NAVY DEPARTMENT BUREAU OF ENGINEERING

Test on Controller and Pulsators for Truck and Screened Speed Lights.

Navy Yard Portsmouth, N.H.

NAVAL RESEARCH LABORATORY ANACOSTIA STATION WASHINGTON, D.C.

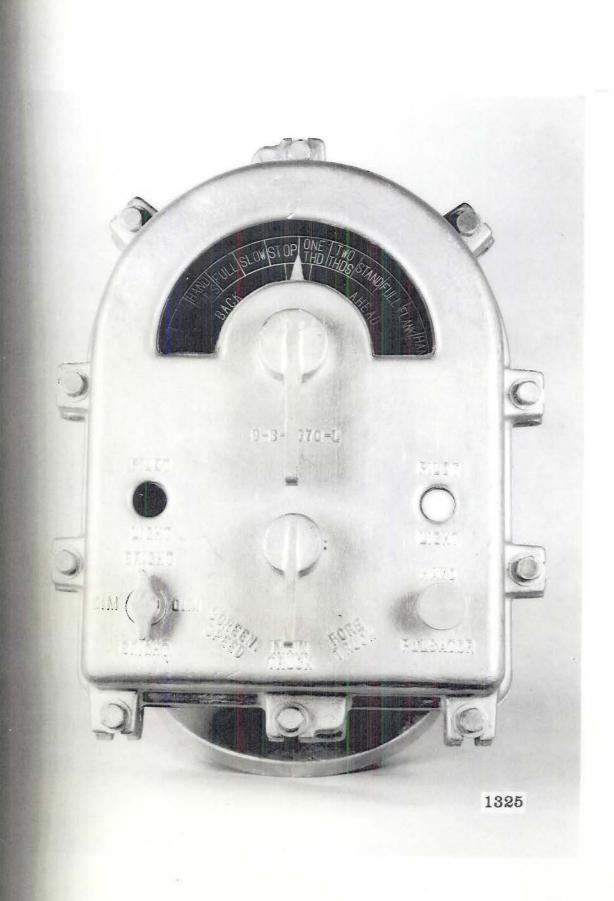
- 20. During the endurance test, both relays, when operating on either D.C. or A.C., were unreliable and frequently failed to operate the pilot lamps. This condition is due to the failure of the armatures to return to their normal positions at the time the current is interrupted by the pulsator. Although there is a brass insert provided for each armature for the residual air gap, the spring, if given sufficient tension to overcome the residual magnetism produced by maximum current, will prevent the armature from operating at minimum current. Relays having sufficient torque for positive operation at minimum current should be substituted. The pilot lights are the only means of indicating that the truck light circuit is functioning correctly, and for that reason, this laboratory cannot over-stress the importance of providing dependable relays.

- 21. The pilot light relays, in their present location, are inaccessible and some method should be provided whereby the relays could be reached for making adjustments without necessitating the removal of the controller case cover and panel. A cover of sufficient size, located on the under side of the controller case, would allow better access to the relays and their removal, if necessary, providing the relays were equipped with flexible lead wires of sufficient length. A better method would be to remove the relays from the controller case and install them in a water-tight case, with removal cover attached to the controller pedestal.

- 22. With the controller connected to alternating current and in the "off" position, both of the neon pilot lamps glow continuously. This is due to the relays opening only one side of the pilot light circuit and capacitive coupling between that circuit and the other side of the line. This is characteristic of Navy Type VG-2 lamps, and past experience has shown, that for proper operation, both sides of the line should be broken.

- 25. The controller dial is now illuminated with Navy Type VG-2 neon lamps. For proper illumination the dial should be painted with radium luminous paint of the 20 micro-lambert grade, using the proper coverage, and activated with Navy type VG-2A lamps.

- 26. In order to conserve the life of the radium luminous paint on the controller dial, the activating Navy Type VG2-A lamps should be cut off with double pole switches when the instrument is not in use.

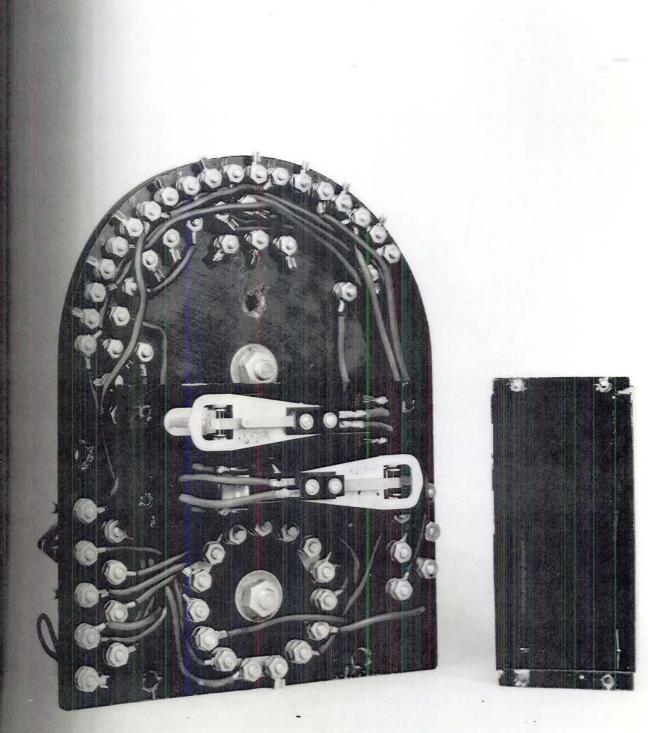
- 23. The locking device, for contact adjusting screws on pulsators, should be modified so as to firmly hold the screw after the adjustment is made.
- 24. The present controller handle is difficult to grasp and operate and should be modified.
